Access Compliance Report

Public Rights-of-Way

Intersection ID: 54779	Main Street: INDEPENDENCE/I-277_RA	Cross Street: N_SHARON_AMITY_RD	Location: NE
ADA ID: 0D3275BB1082	Ramp Type: Perp	Initial Pass/Fail: Fail	Overall Compliance: No
Severity Score: 12.5			
Codes/Mitigation Info/Possible Solution		Field Measurements/Component Compliance

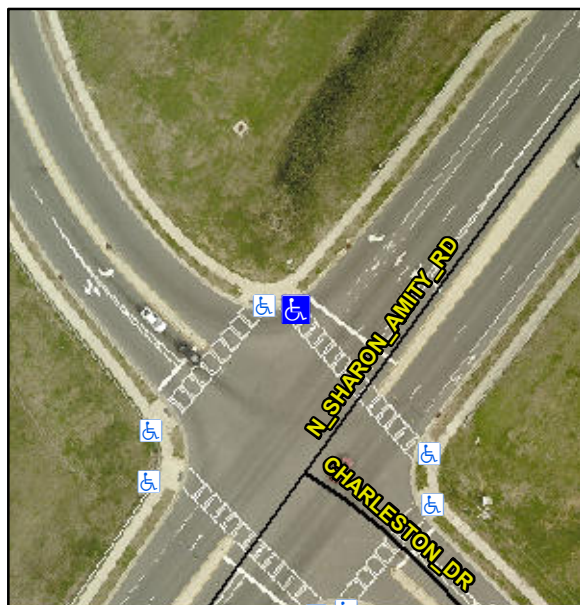
R304.5.3

Compliance	Description	Data	Compliance	Description	Data
N/A	Ramp Length (in)	65.0	Yes	Ramp Slope (%)	5.8
Yes	Ramp Width (in)	59.0	No	Ramp XSlope (%)	5.2
N/A	Flare Type LT	N/A	N/A	Flare Type RT	N/A
N/A	Flare Slope LT (%)	N/A	N/A	Flare Slope RT (%)	N/A
N/A	Flare Traversable LT?	N/A	N/A	Flare Traversable RT?	N/A
N/A	Landing Length (in)	N/A	N/A	DWS Provided?	N/A
N/A	Landing Width (in)	N/A	N/A	DWS Contrast?	N/A
N/A	Landing Slope (%)	N/A	N/A	DWS Length (in)	N/A
N/A	Landing X Slope (%)	N/A	N/A	DWS Full Width?	N/A
N/A	Landing Curb? (Y/N)	N/A	N/A	DWS Offset (in)	N/A
N/A	Shared Landing?	N/A			
N/A	Gutter Ponding?	N/A	N/A	Gutter Slope (%)	N/A
N/A	Gutter Lip Ht (in)	N/A	N/A	Gutter X Slope (%)	N/A
N/A	Painted X Walk1?	Yes	N/A	Painted X Walk2?	N/A
	X Walk 1 Direction	To SE		X Walk 2 Direction	N/A
N/A	X Walk 1 Width (in)	112.0	N/A	X Walk 2 Width (in)	N/A
	X Walk 1 Slope (%)	2.7		X Walk 2 Slope (%)	N/A
	X Walk 1 X Slope (%)	6.3		X Walk 2 X Slope (%)	N/A

Remove & Replace Entire Ramp.
